# **Intel<sup>®</sup> Pentium<sup>®</sup> III Xeon<sup>™</sup> Processor Specification Update**

Release Date: February 2001

Order Number: 244460-025

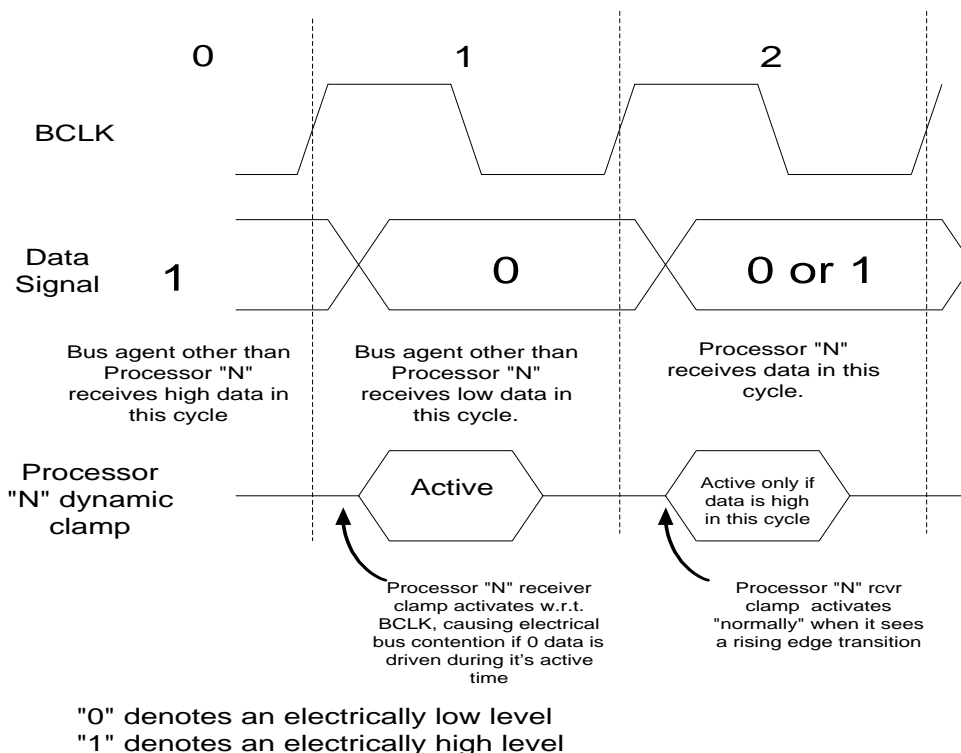
**Workaround:** The AGTL+  $V_{REF}$  (input voltage reference) level will be raised from 1.0V to 1.1V (assuming a  $V_{TT}$  of 1.5V) on the processor cartridge substrate. This allows the dynamic clamp to activate at a trigger level approximately 100 mV higher than with the previous 1.0V  $V_{REF}$  setting. Due to the dependence upon system bus design, bus layout may be evaluated to determine the need for improvements in falling edge ringback levels. This may involve one or several of the following baseboard modifications:

1. Change termination resistor value to reduce multi-bit noise and/or improve  $V_{IL}$  noise margin.
2. Reduce multi-bit noise by improving ground return paths (additional high-frequency decoupling, improved AC plane referencing, etc.).
3. Raising or lowering the  $V_{TT}$  level (within the AC & DC tolerances specified in the processor EMTS) to improve  $V_{IL}$  noise margin and/or reduce the multi-bit noise due to  $dl/dt$  transients.

Stress tests using various data patterns and transactions should be run to identify the worst-case multi-bit noise conditions for this erratum.
